REMEDIATION SYSTEM EVALUATION

SMS INSTRUMENTS  
DEER PARK, NEW YORK

Report of the Remediation System Evaluation,  
Site Visit Conducted at the SMS Instruments Superfund Site  
July 16, 2003

Final Report  
December 9, 2003

**FIGURE 1-2. THE FORMER SMS INSTRUMENTS FACILITY, SURROUNDING AREA, AND WELL LOCATIONS.**

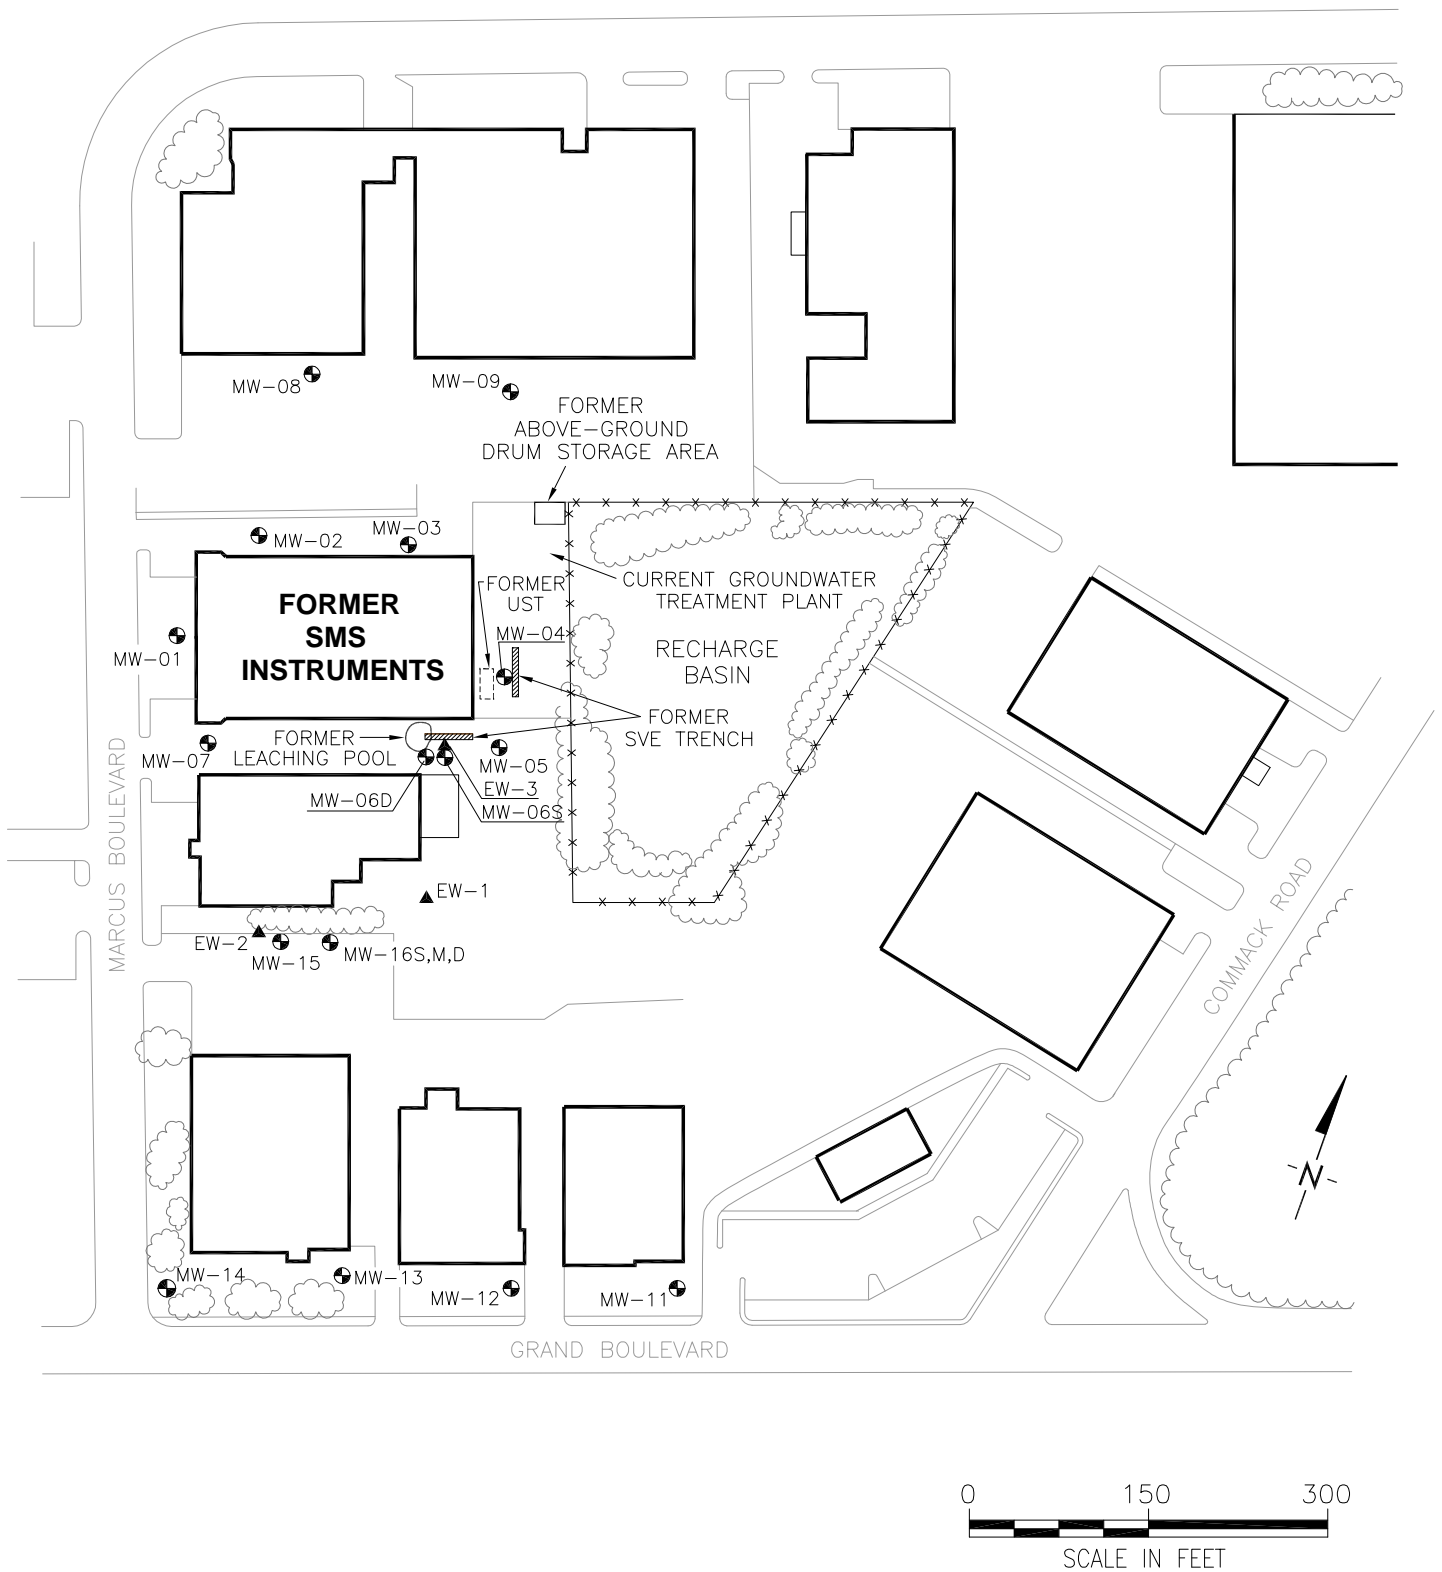
Figure 1-2 presents the locations of these wells and shows that MW-6S and EW-3 are located adjacent to each other in the area of the former leaching pond. No monitoring points are located between this area and EW-1, but given the continued contamination at EW-1, it is likely that this intermediate area has contamination above cleanup standards.

FIGURE 4-1. VOC CONCENTRATION TREND IN MW-6S

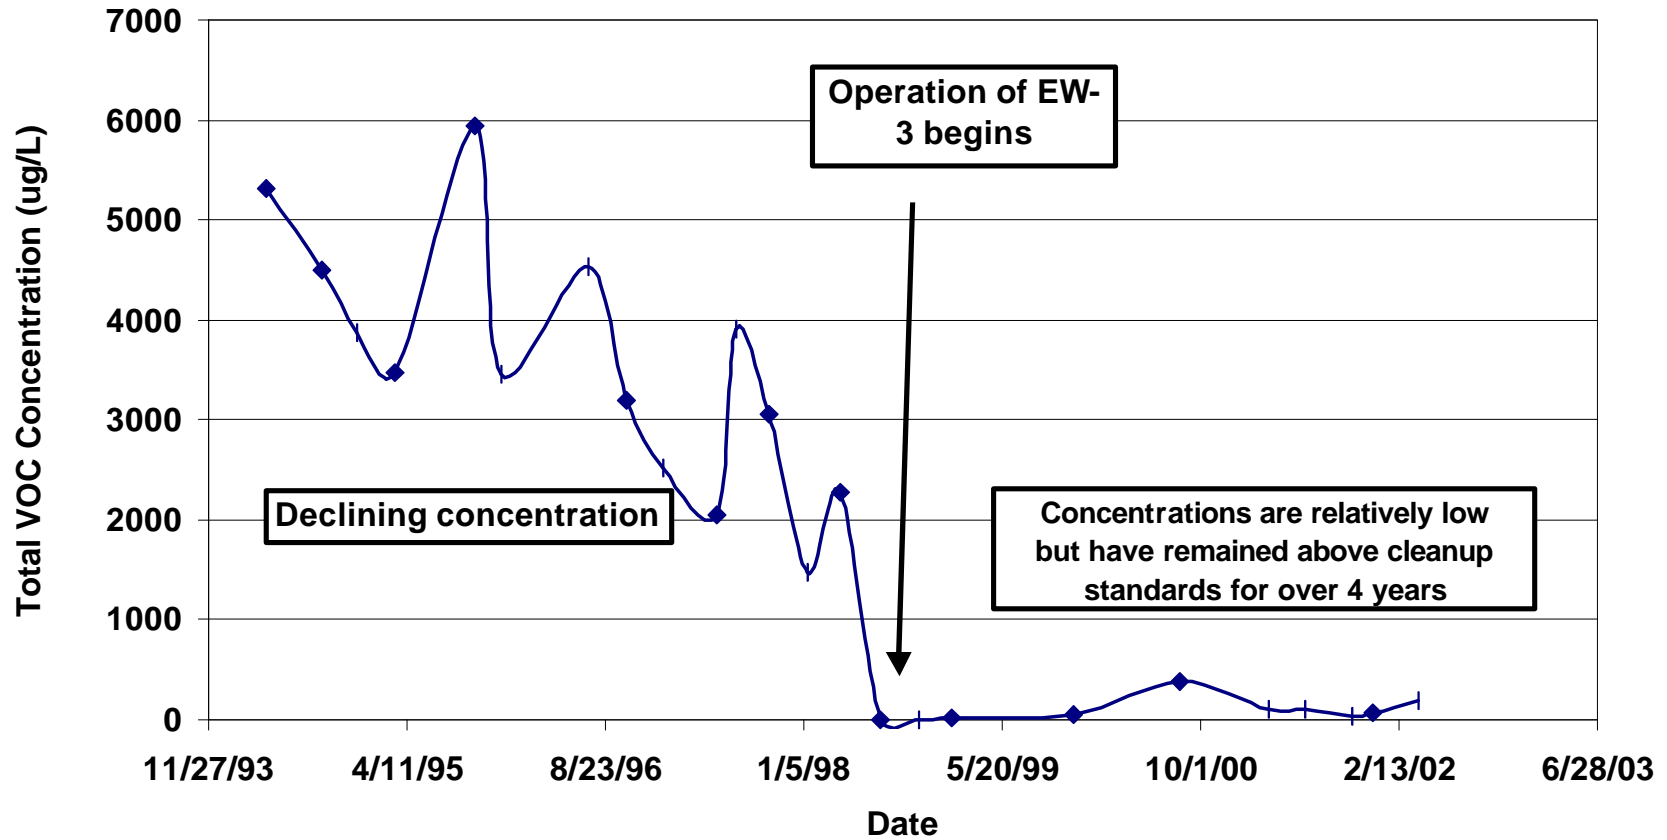
As is evident from the tables, most contaminant concentrations have decreased by over an order of magnitude from the time of the Remedial Investigation. For many of the chlorinated compounds, such as tetrachloroethene and trichloroethene, the decrease in concentration may also be due to dechlorination caused by microbial activity using the other organics as nutrients and the chlorinated compounds as electron acceptors. Figure 4-1 shows that total VOC concentrations at MW-6S were decreasing between 1994 and 1998 and that the decrease was substantially accelerated by the addition of EW-3. Figure 4-2 also shows that concentrations have been low since 1998. They are, however, not low enough to meet the cleanup standards and conditions have been nearly stable (with fluctuations) for approximately four years.

The VOC concentration in MW-6S (source area) declined between 1994 and 1998 due to the natural flushing of clean water through the site. EW-1, located at the downgradient boundary of the site, was installed to capture contamination before it moved offsite. The 1998 installation of EW-3 in the source area accelerated aquifer restoration. Concentrations are orders of magnitude lower than during the original investigations; however, they have remained consistently above cleanup standards. Data collected in sampling events since April 2002 have not been processed or reported as of July 2003.

**FIGURE 4-2. THE EXTENT OF SITE-RELATED AND NON-SITE RELATED CONTAMINATION.**

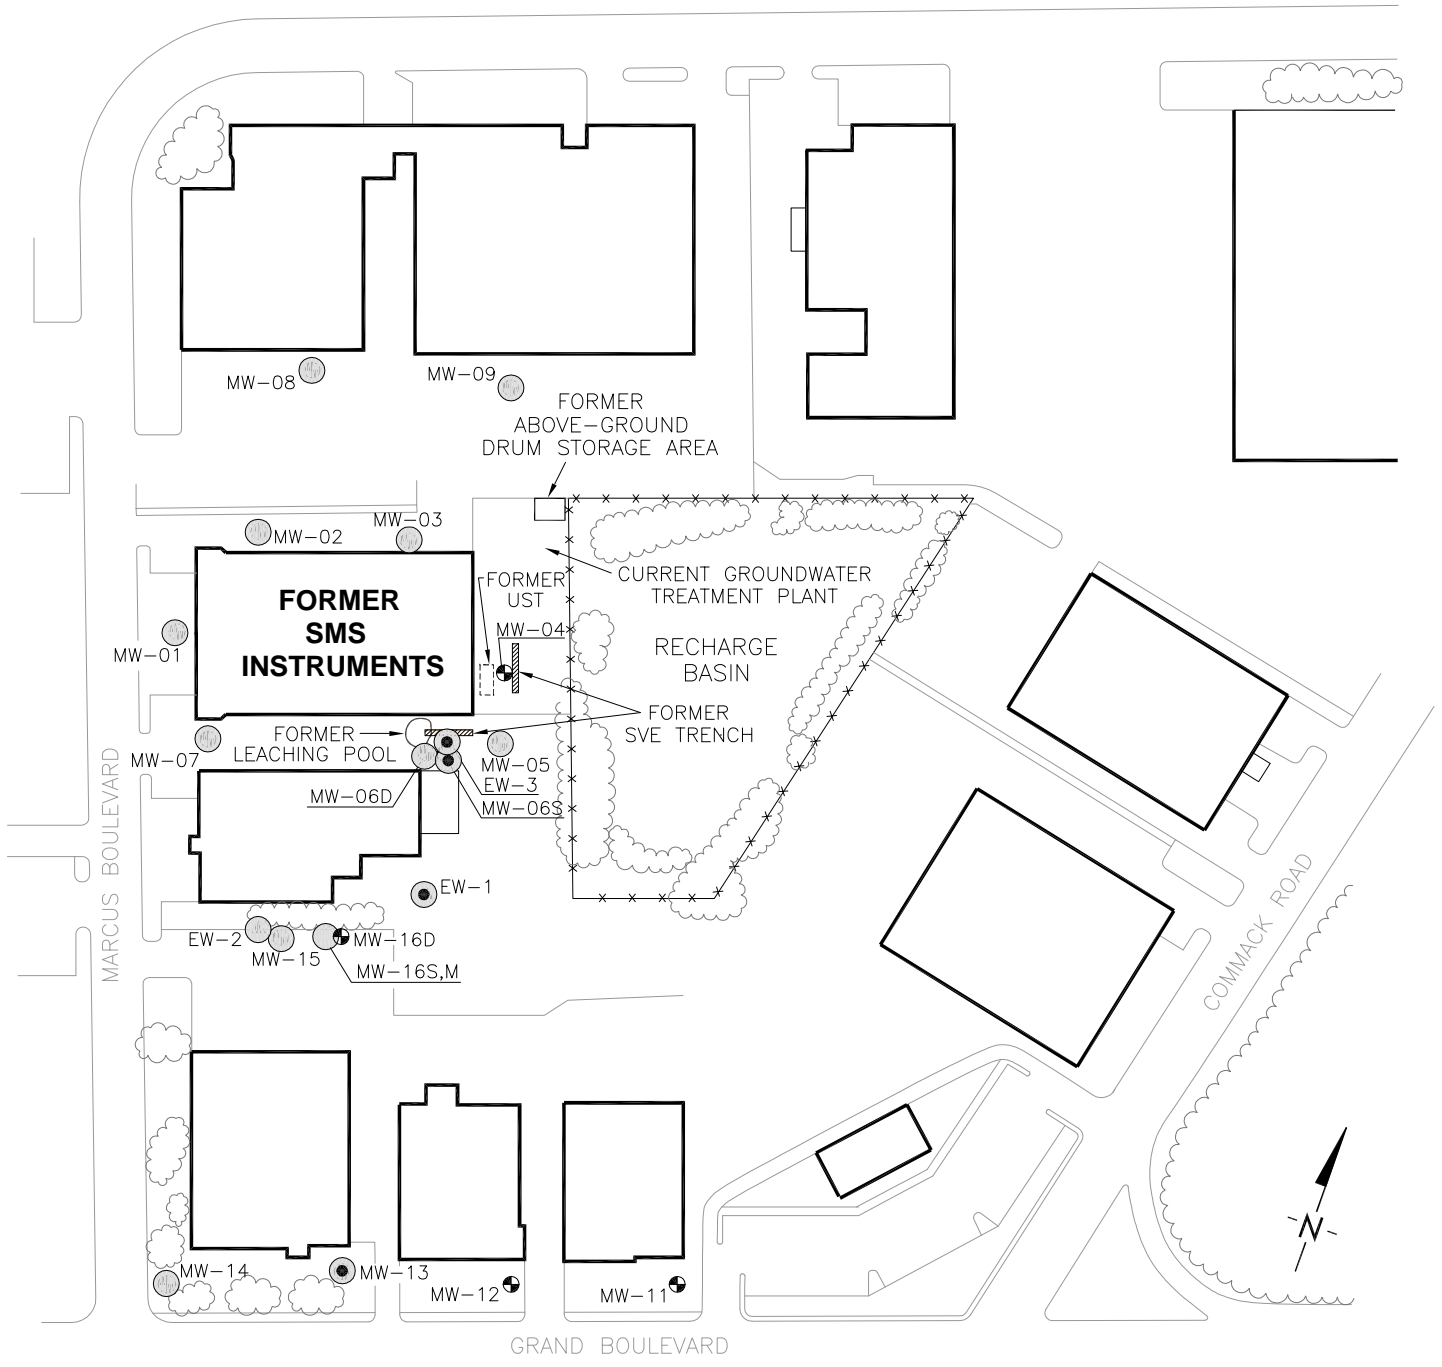
The RSE team also believes that ground water contamination from upgradient will continue to flow through the site and will affect the ability of the site team to close the site if it does not distinguish between the contamination that is site-related and the contamination that is not site-related. In particular, the RSE team sees 1,1-dichloroethane and 1,1,1-trichloroethane as contaminants from upgradient. As shown in Figure 4-2, these constituents are found throughout the site, including the upgradient wells. Contrastingly, the site-related contaminants, including a variety of benzene-related compounds, are limited to the former source area and the immediate area downgradient (EW-1, EW-3, and for a brief period, MW-13). In addition, 1,1-dichloroethane and 1,1,1-trichloroethane were not detectable in the surface or subsurface soils during the Remedial Investigation indicating that they were not part of the original site-related source material.
